ADDENDUM No. 1: May 8, 2015

PROJECT: St. John the Baptist Parish
Volunteer Fire Station #51
LaPlace, Louisiana

PROJECT NO.: SA 21167.00

1 ENLARGED SECOND FLOOR PLAN - FIREMAN'S LADDER (1/A202)
 ASK001 1/4" = 1'-0"

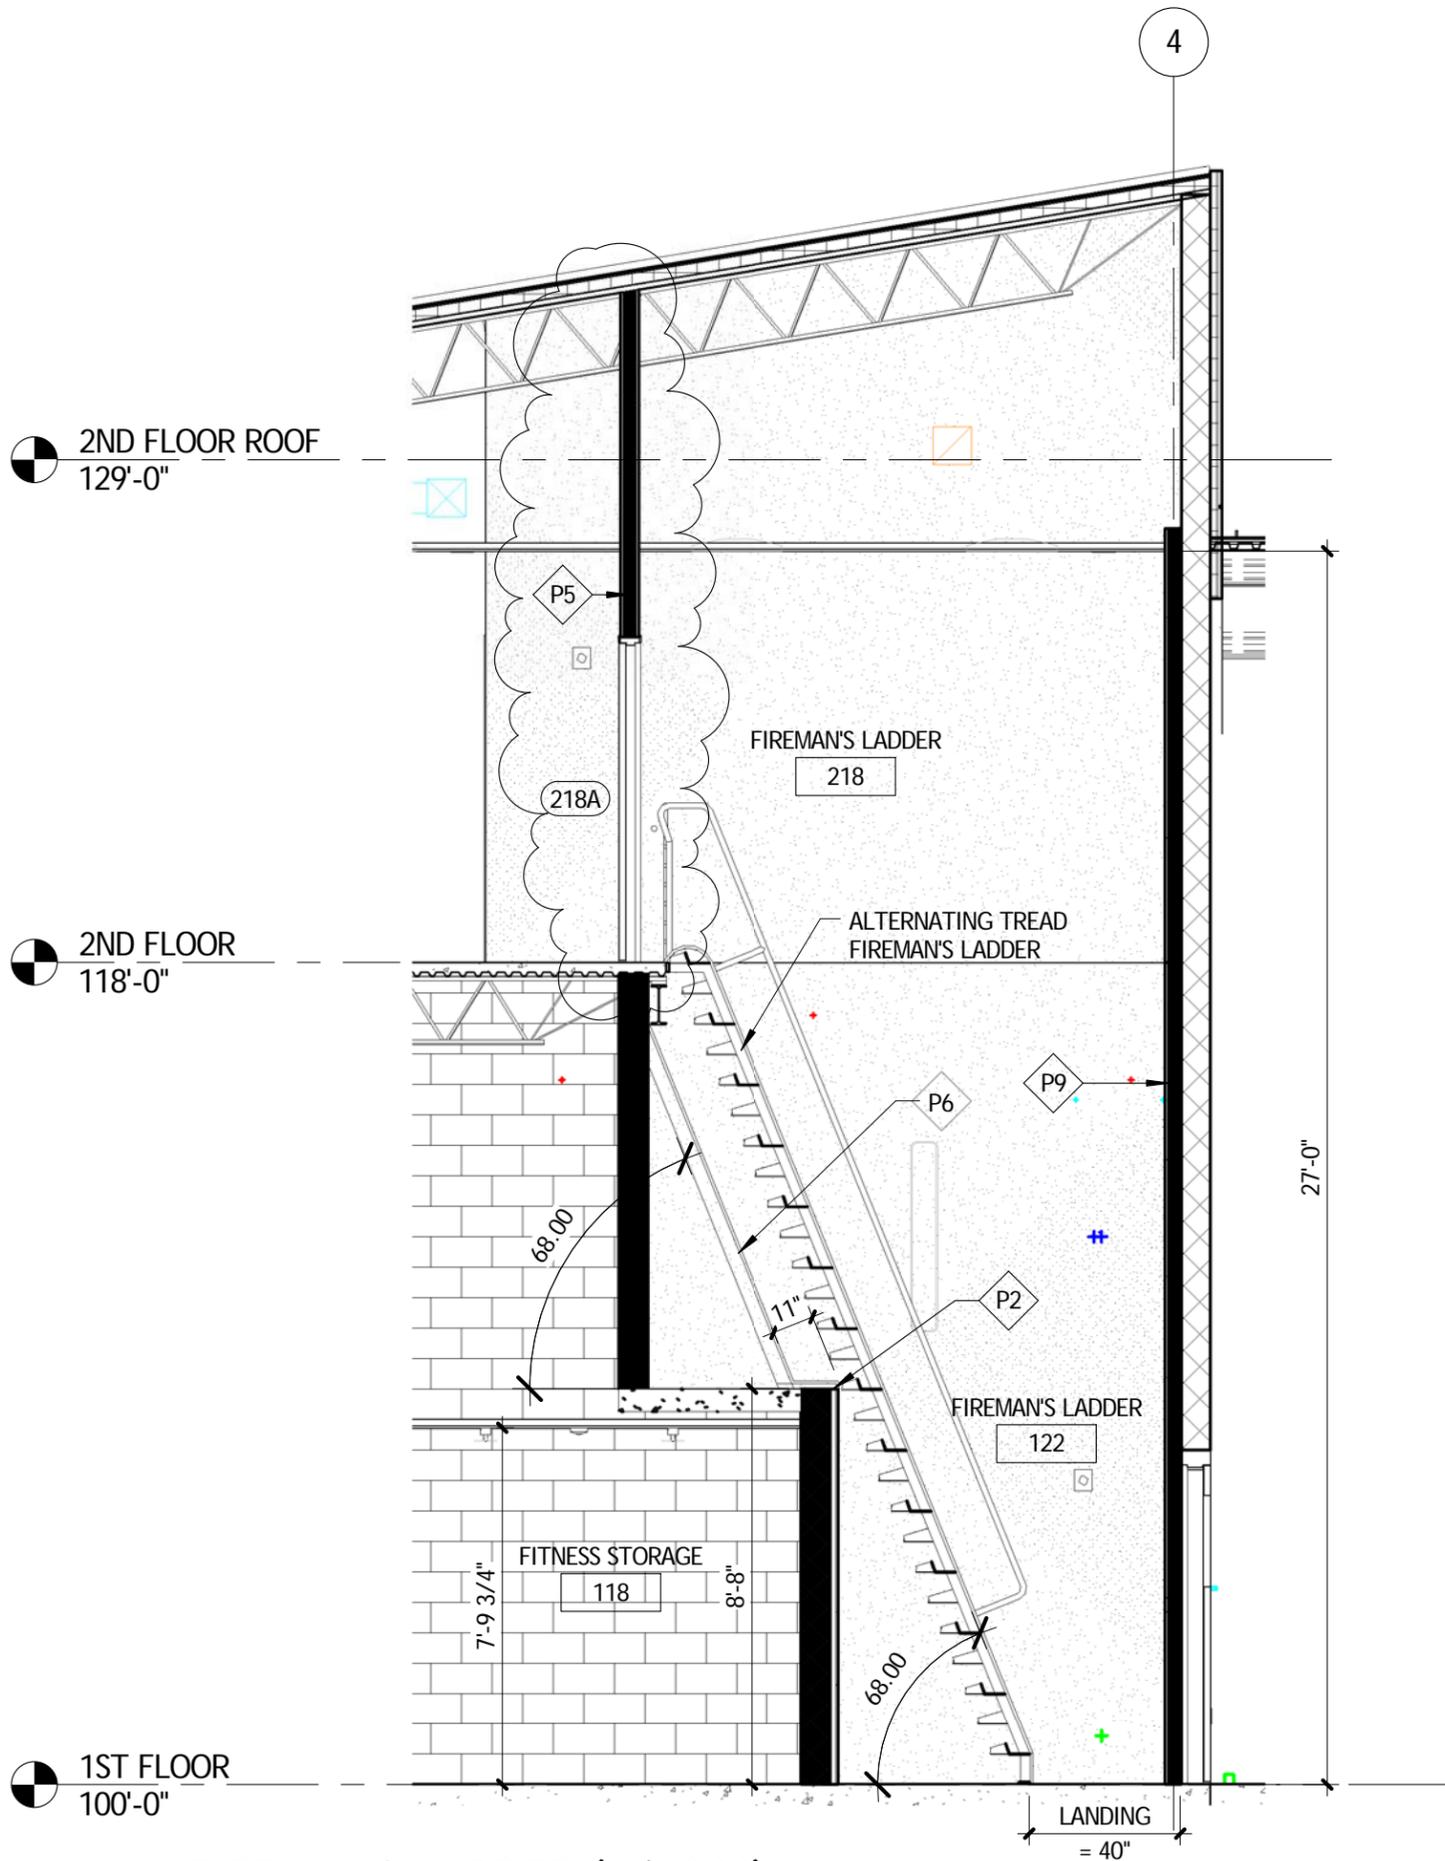
Revise Second Floor Plan 1/A202 as shown on attached sketch ASK001.

Revise Building Section 1/A322 as shown on attached sketch ASK001.

1
SSK001

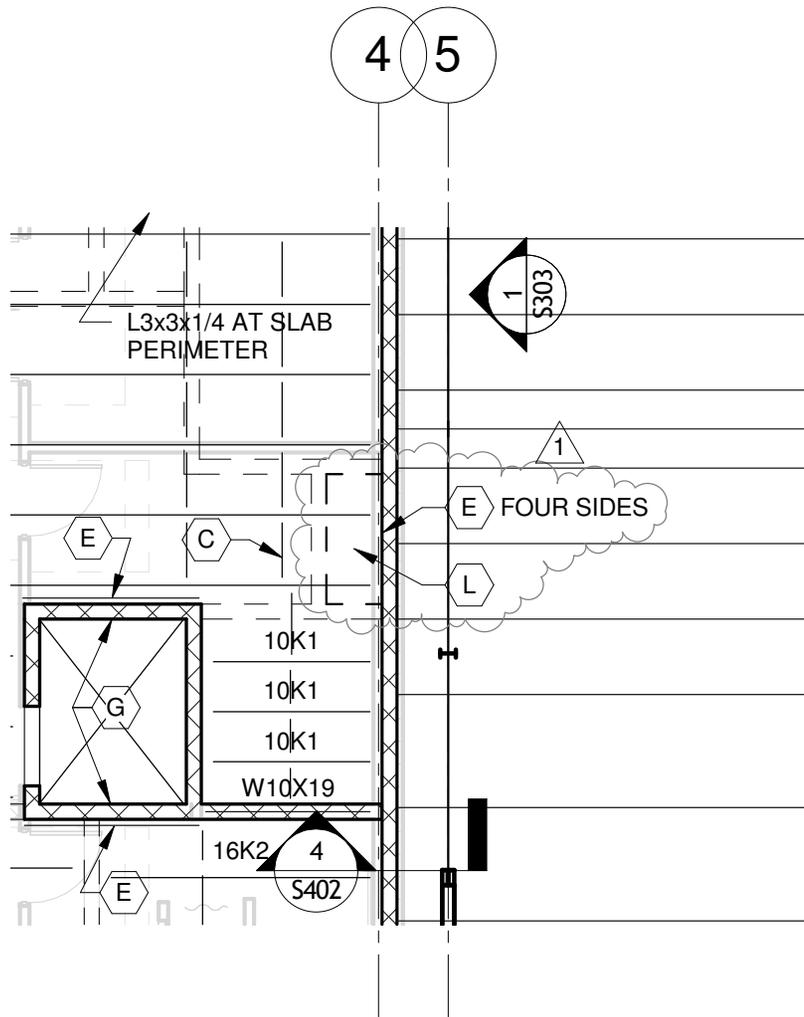
Revise Second Floor and Roof Framing Plan as shown on attached sketch SSK001.

project number	21167.00	drawing number	<h1>M101r</h1>	
	date	February 20, 2014	phase		BIDDING

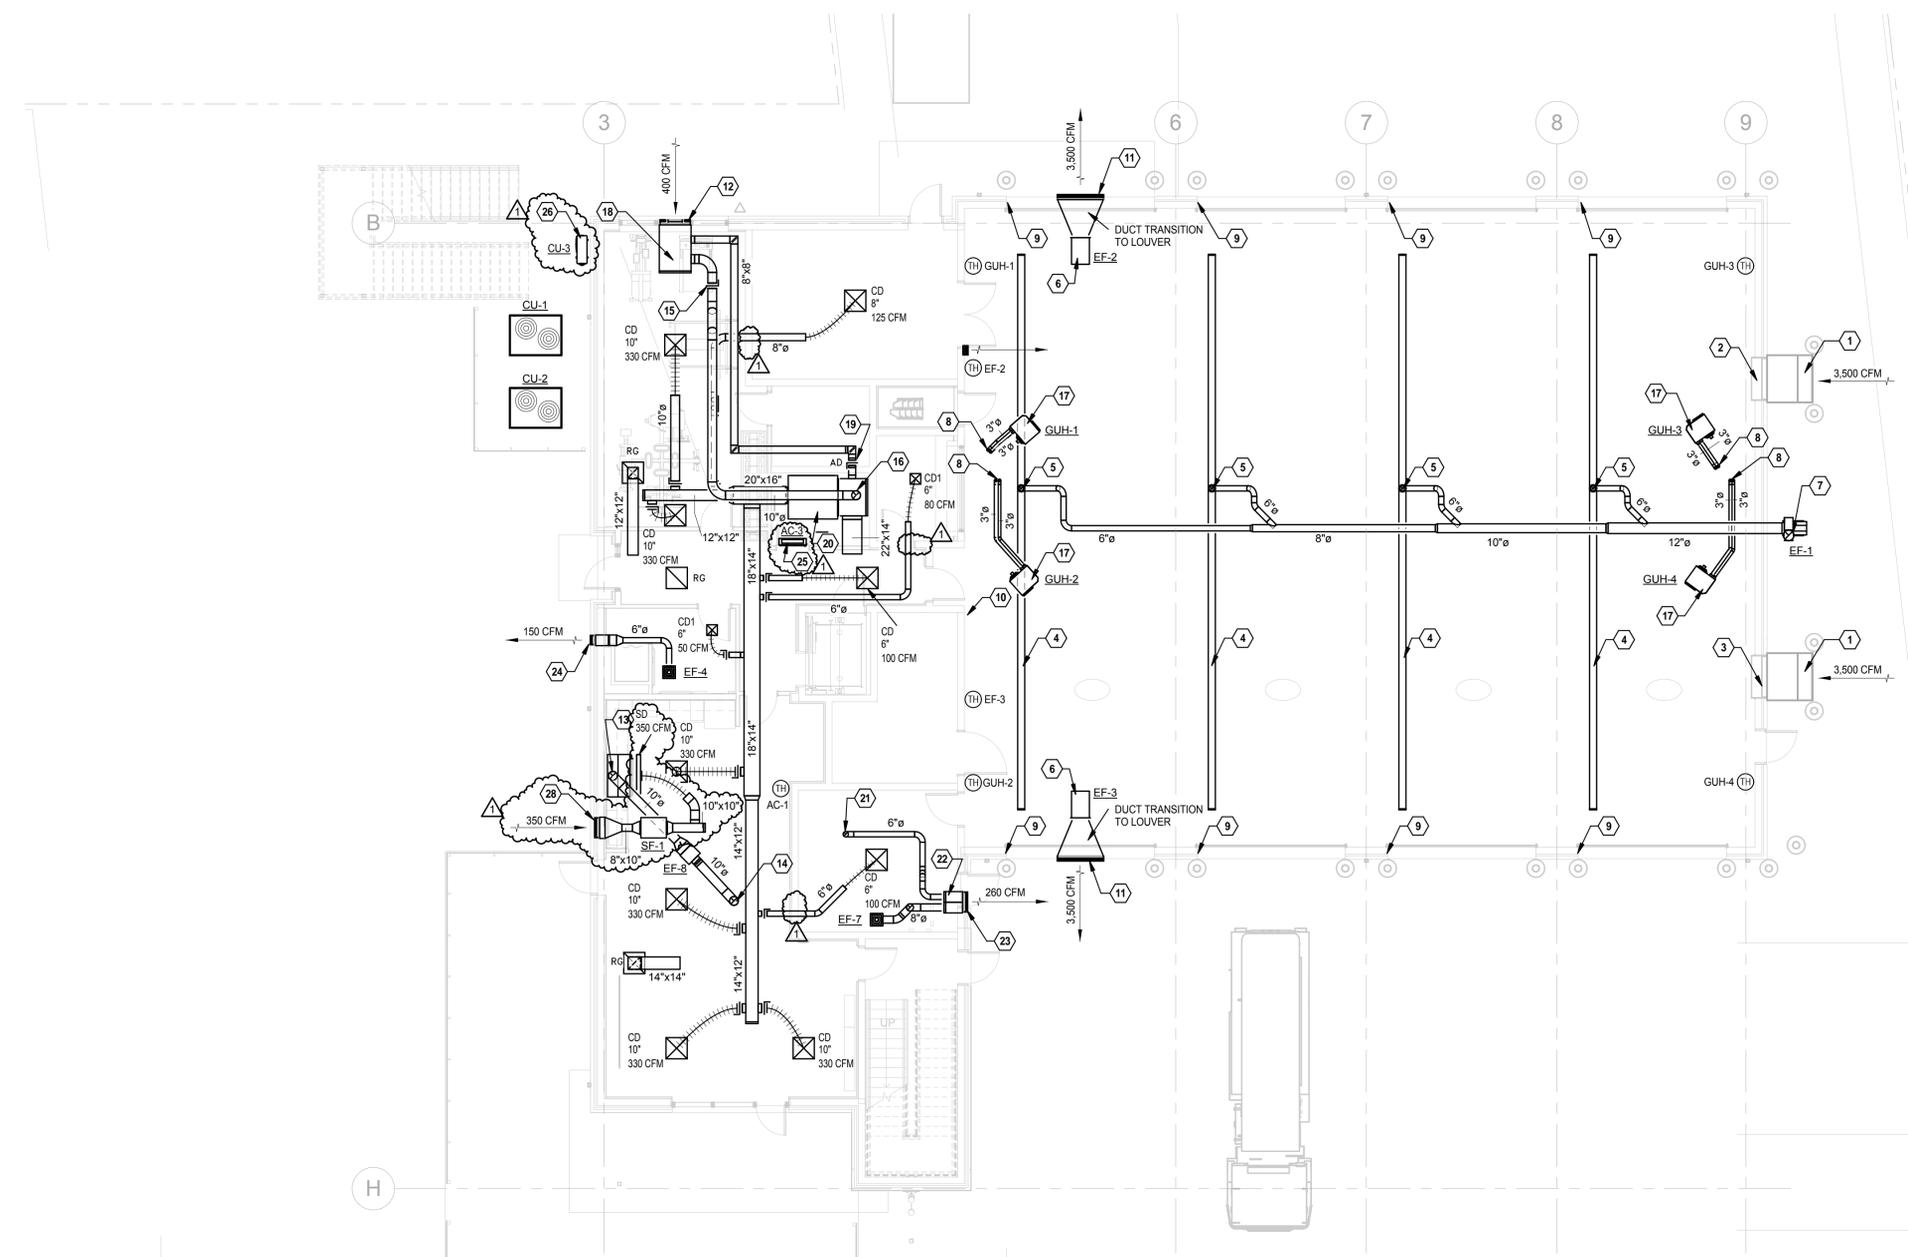
Remove Sheet M101 in its entirety; in lieu thereof replace with attached reissued sheet **M101r**. Revised First Floor HVAC Plan. Ductless split system AC-3/CU-3 was added. Make up air supply fan SF-1 was added. The fire dampers were removed from the first floor.

1 Plumbing - Under First Floor
P100r 1/8" = 1'-0"

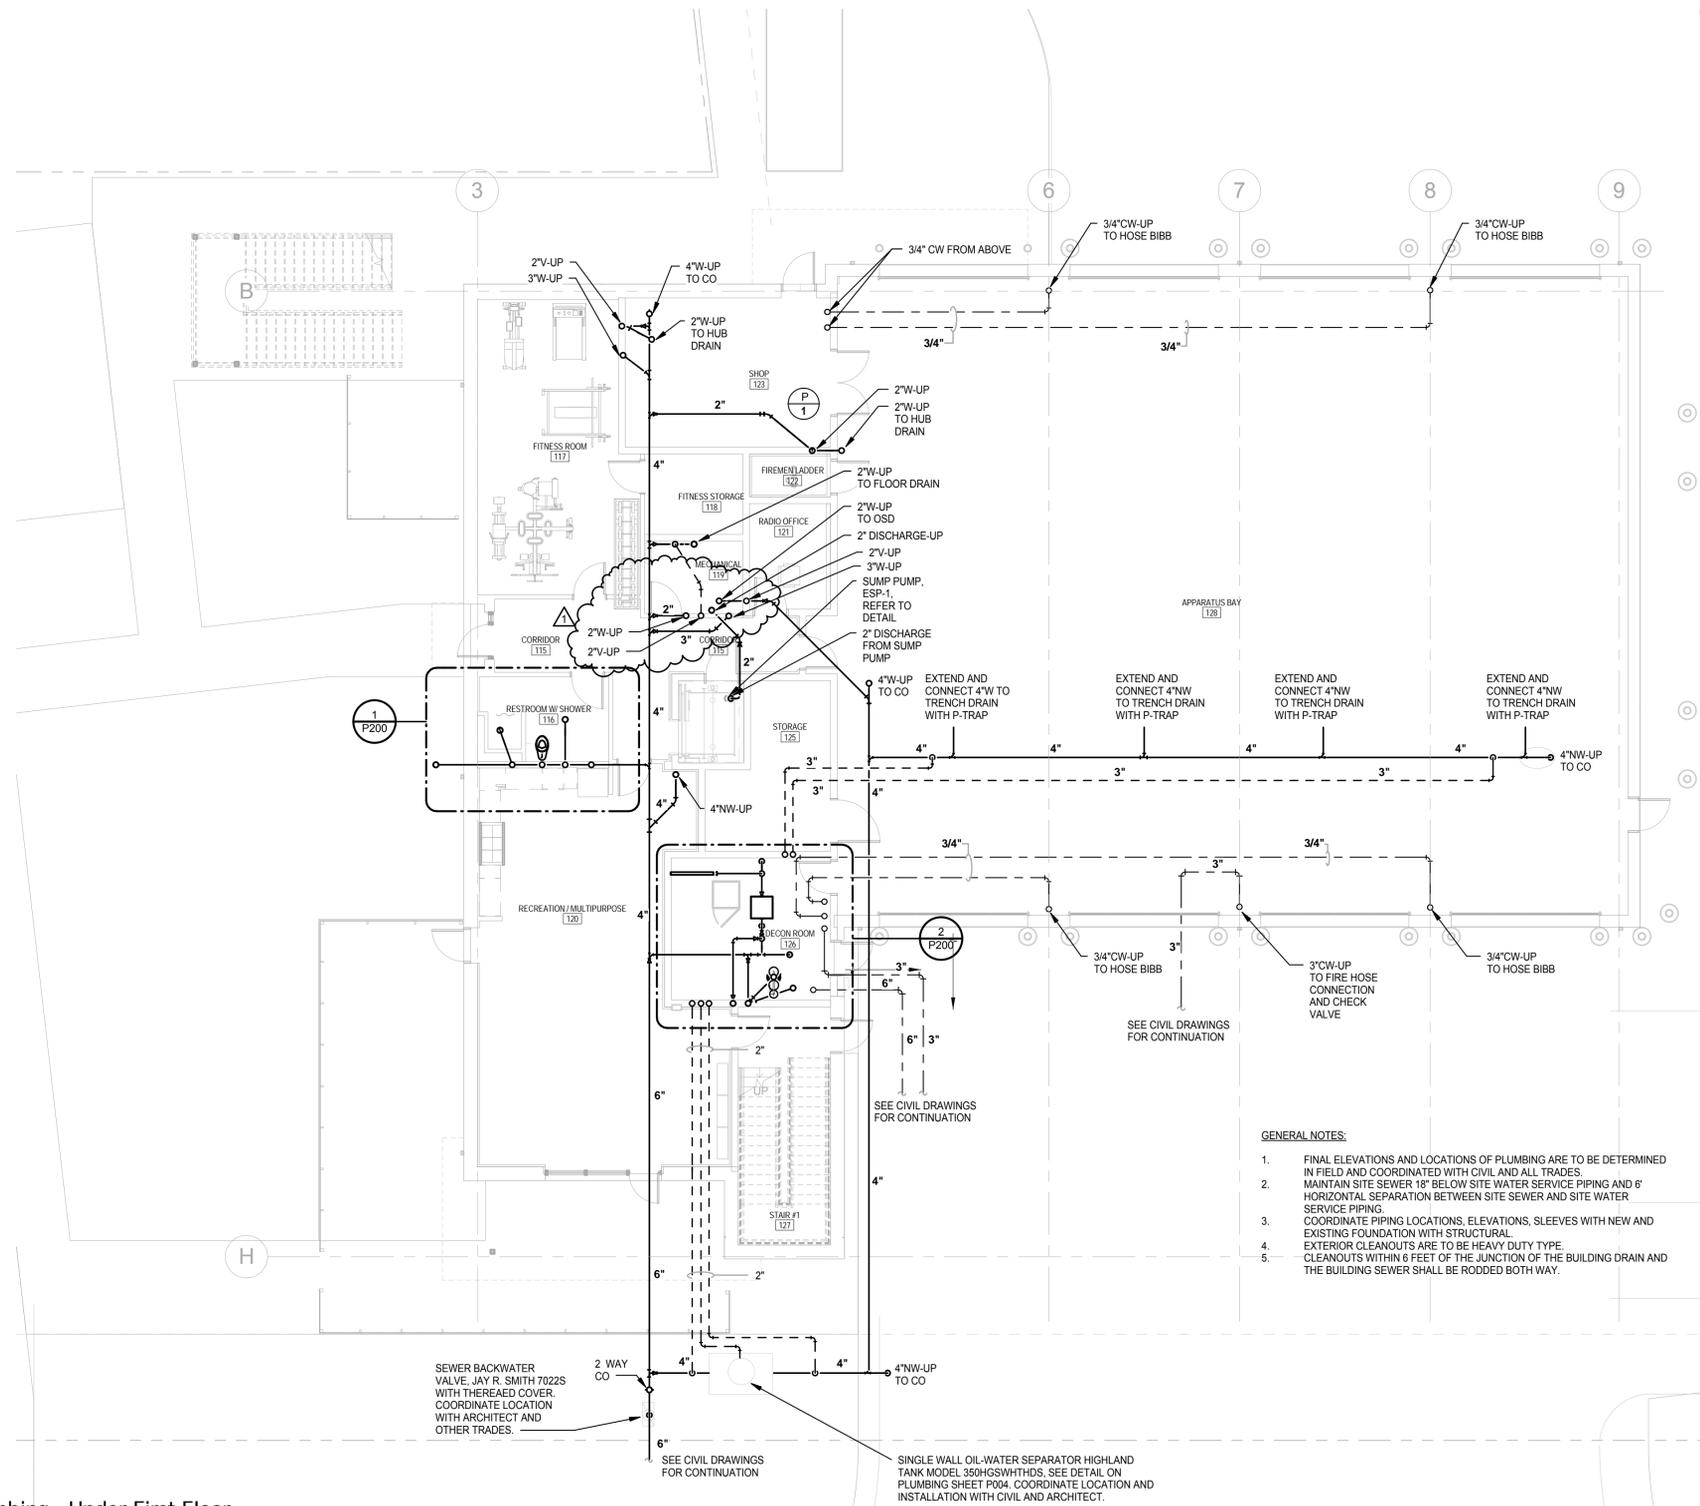
Remove Sheet P100 in its entirety; in lieu thereof replace with attached reissued sheet P100r. Revised First Floor Underground Plumbing Plan. Drainage was added for the new ductless split system AC-3/CU-3.

project number	21167.00	drawing number	P101r
	date	February 20, 2014		
	phase	BIDDING

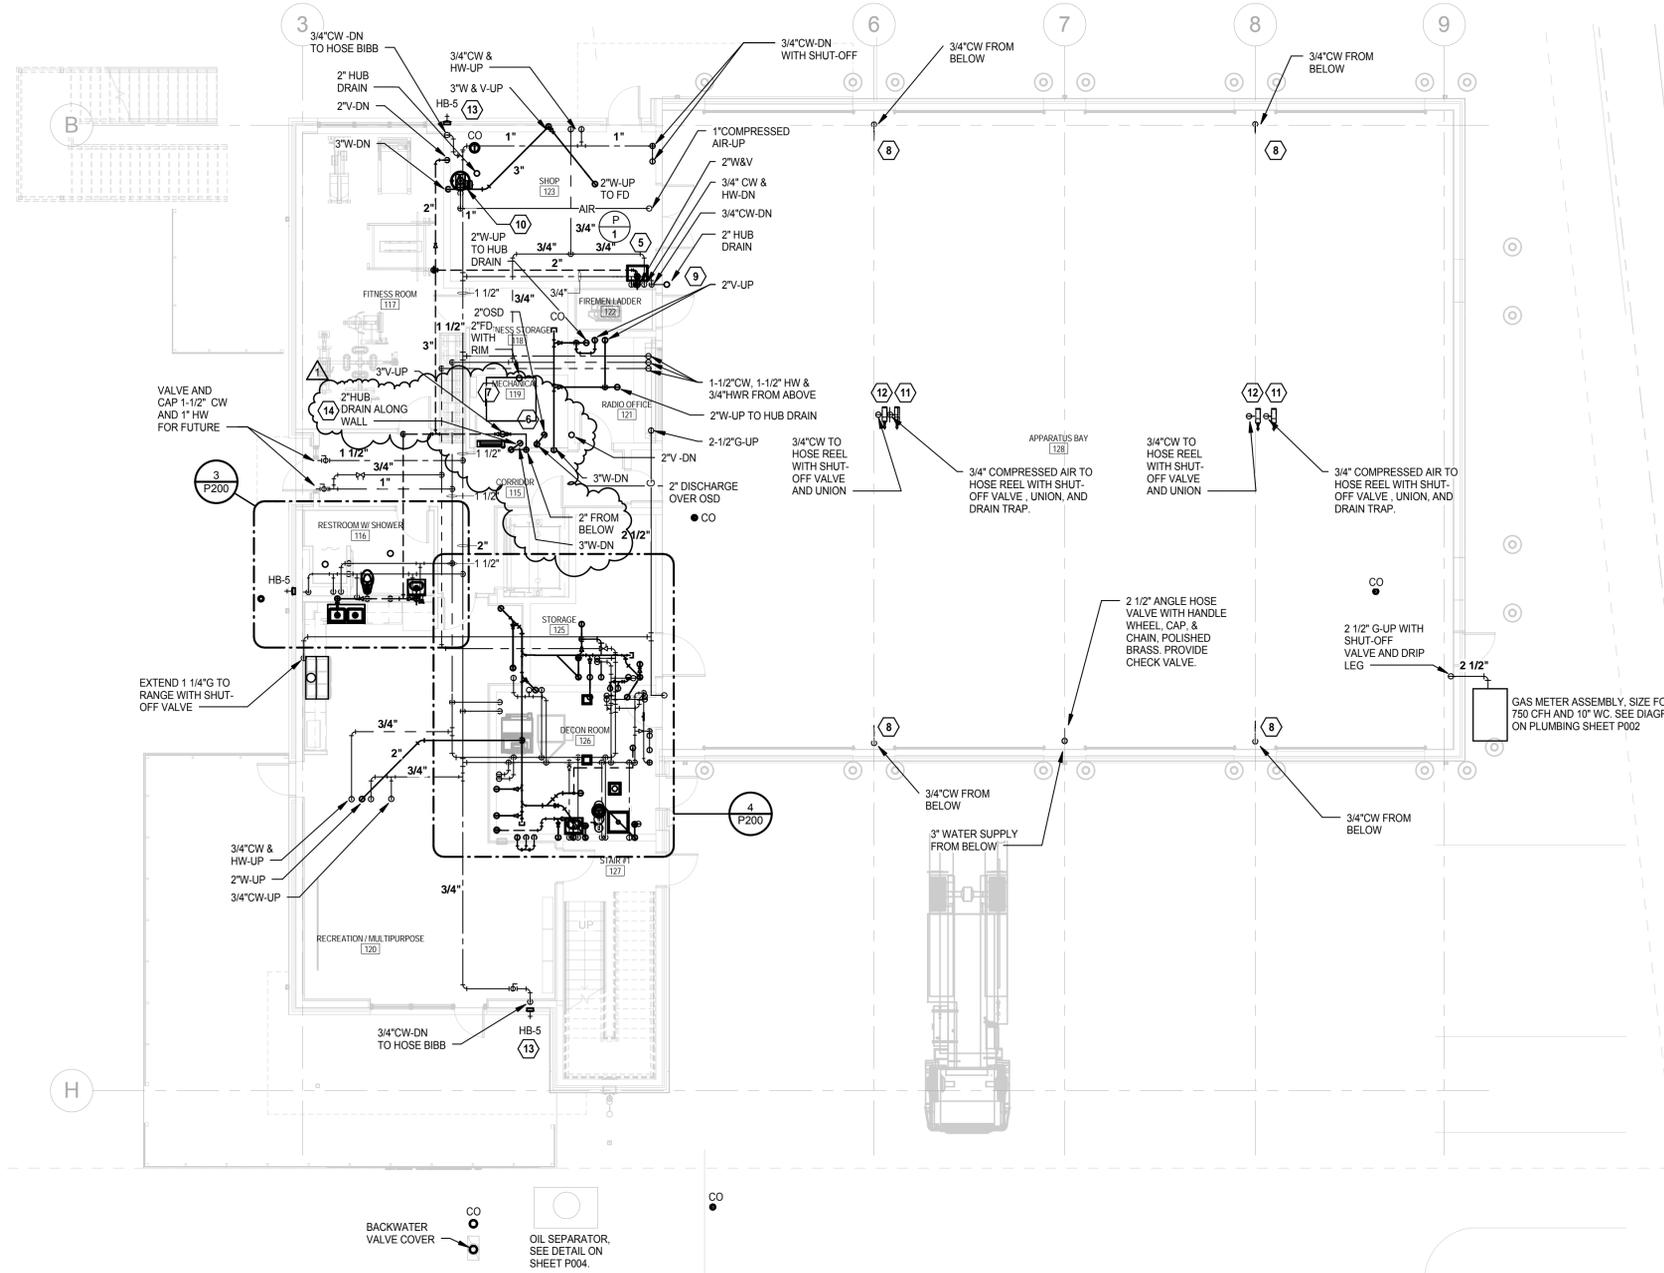
Remove Sheet P100 in its entirety; in lieu thereof replace with attached reissued sheet P101r. Revised First Floor Plumbing Plan. Drainage was added for the new ductless split system AC-3/CU-3.
